Access Compliance Report

Public Rights-of-Way

(Curb Ramps)

Intersection ID: 17815	Main Street: IDLEWILD_RD	Cross Street: VESTAL_PL	Location: SW
ADA ID: E01089F31C45	Ramp Type: PerpDiag	Initial Pass/Fail: Fail	Overall Compliance: No
Severity Score: 12.5			
Codes/Mitigation Info/Possible Solution		Field Measurements/Component Compliance

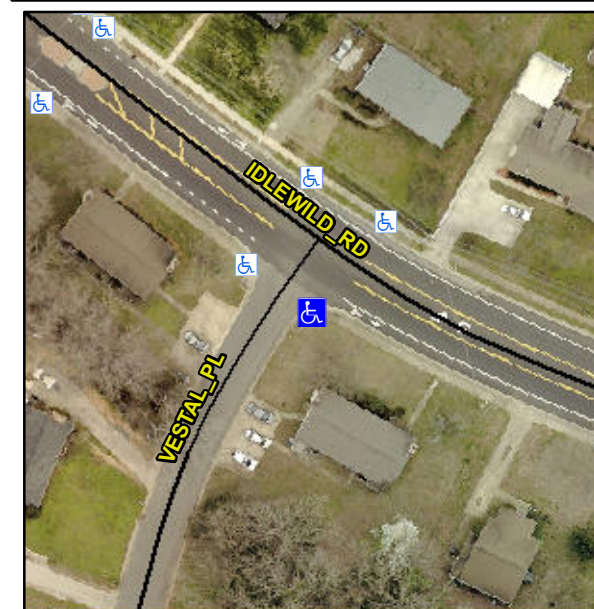
Not Found, R304.2.2

Compliance	Description	Data	Compliance	Description	Data
N/A	Ramp Length (in)	62.0	No	Ramp Slope (%)	9.2
Yes	Ramp Width (in)	48.0	Yes	Ramp XSlope (%)	1.9
N/A	Flare Type LT	N/A	N/A	Flare Type RT	N/A
N/A	Flare Slope LT (%)	N/A	N/A	Flare Slope RT (%)	N/A
N/A	Flare Traversable LT?	N/A	N/A	Flare Traversable RT?	N/A
N/A	Landing Length (in)	N/A	N/A	DWS Provided?	N/A
N/A	Landing Width (in)	N/A	N/A	DWS Contrast?	N/A
N/A	Landing Slope (%)	N/A	N/A	DWS Length (in)	N/A
N/A	Landing X Slope (%)	N/A	N/A	DWS Full Width?	N/A
N/A	Landing Curb? (Y/N)	N/A	N/A	DWS Offset (in)	N/A
N/A	Shared Landing?	N/A			
N/A	Gutter Ponding?	N/A	N/A	Gutter Slope (%)	N/A
N/A	Gutter Lip Ht (in)	N/A	N/A	Gutter X Slope (%)	N/A
N/A	Painted X Walk1?	No	N/A	Painted X Walk2?	No
	X Walk 1 Direction	To NE		X Walk 2 Direction	To NW
N/A	X Walk 1 Width (in)	N/A	N/A	X Walk 2 Width (in)	N/A
	X Walk 1 Slope (%)	6.3		X Walk 2 Slope (%)	9.4
	X Walk 1 X Slope (%)	4.3		X Walk 2 X Slope (%)	2.9

N/A	Ramp inside XWalk1?	N/A	N/A	Ramp inside XWalk2?	N/A
	Road Slope (%)	0.3	N/A	Clear Space?	N/A
	Road X Slope (%)	9.0	N/A	Clear Space to XWalk (in)	N/A
N/A	Any Obstructions?	N/A	N/A	Storm Grate/Utility Hazard?	N/A
	Obstruction Type			Storm Grate/Utility Type	
		N/A			N/A
		Yes		Surface Condition? (G/P)	Good

Remove & Replace Curb Ramp With Two New Directional Ramps or Equivalent.
